4825 Montgomery Lane LLC, Local Map Amendment, G-908

Staff Report Date: 2/10/12

RECOMMENDATION: Staff recommends **approval** of Local Map Amendment No G 908 for the following reasons:

PROPOSED ELEVATIONS

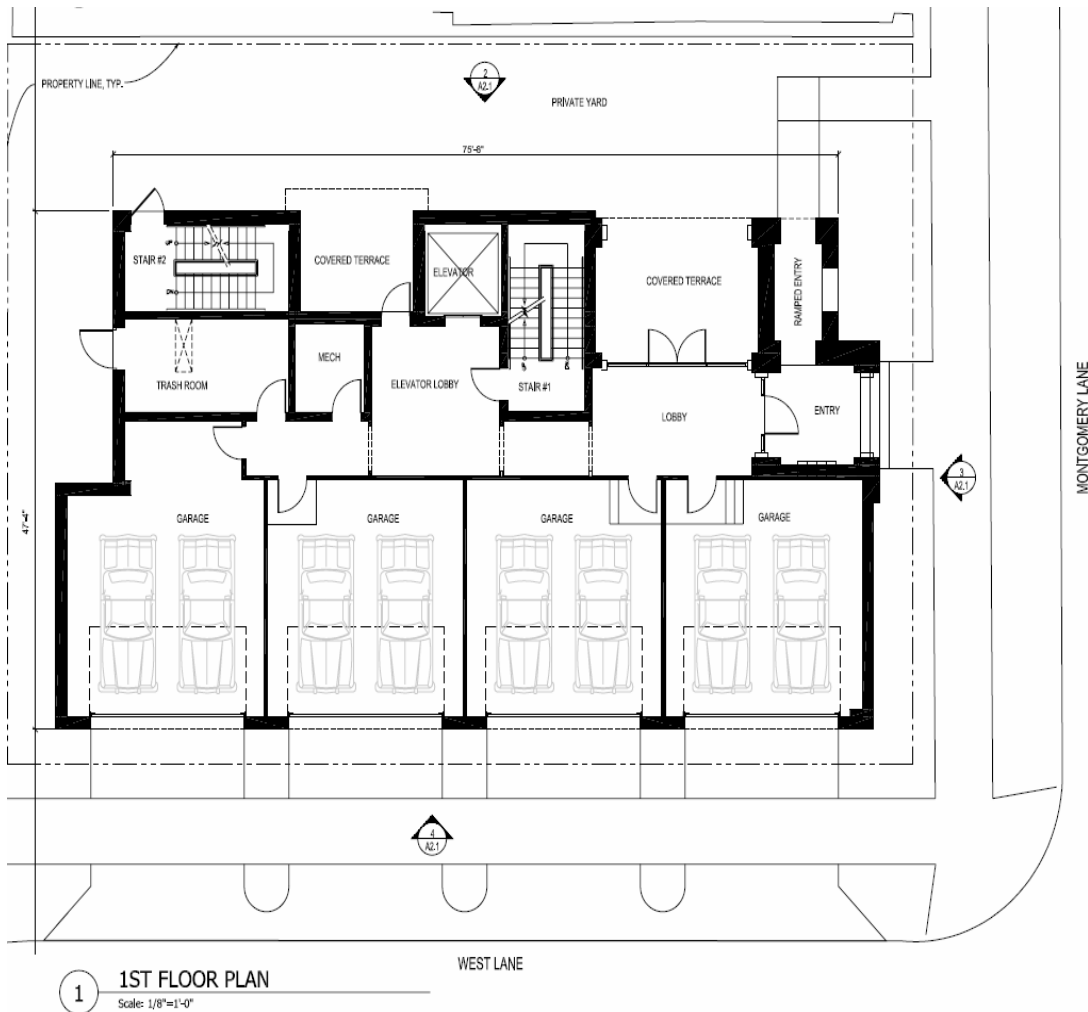
This project proposes a 5 story building that is significantly lower than the adjacent building to the east and as designed fully utilizes the site’s dimensions. The Sector Plan recommends a building height of no more than 65 feet which is equivalent to a 6 story residential building (page 39.) This proposal is consistent with that recommendation as it proposes a five story building that will be 65 feet to the roof line plus an additional 4 feet to the top of the parapet wall. The proposal is also consistent with the Plan guidance to “step down building heights from the Bethesda Metro Center properties to achieve desirable and compatible transitions to adjacent areas.” P. 40

Initially, the applicant submitted a development plan showing the entrance to the proposed building along the site’s eastern property line. After discussion with staff, the plan was revised to place the front entrance to the building on Montgomery Lane in keeping with the above cited Sector Plan recommendation. While the residences are proposed one floor above street level, reorienting the building’s entrance on Montgomery Lane will help increase pedestrian activity on Montgomery Lane which is recommended as a pedestrian oriented “mixed street.” (pages 84 & 86 and pages 180-1). A mixed street is one with slow moving traffic and enhanced features for pedestrians and bicyclists. The idea is that such a street is designed to accommodate a true “mix” of pedestrian, bicyclists and motorized vehicles.

1. Density: maximum number of dwelling units is 4
2. Building height will be 5 floors:
 - a maximum height to the top of the roof is 65 feet
 - a maximum height to the parapet wall is 69 feet
3. The primary pedestrian entrance to the proposed building shall be from Montgomery Lane.
4. A preliminary plan and record plat shall be submitted and approved by the Planning Board showing dedication of one foot along the property frontage on Montgomery Lane and approximately 2 ½ feet along the frontage of West Lane for a total dedication of approximately 308 square feet
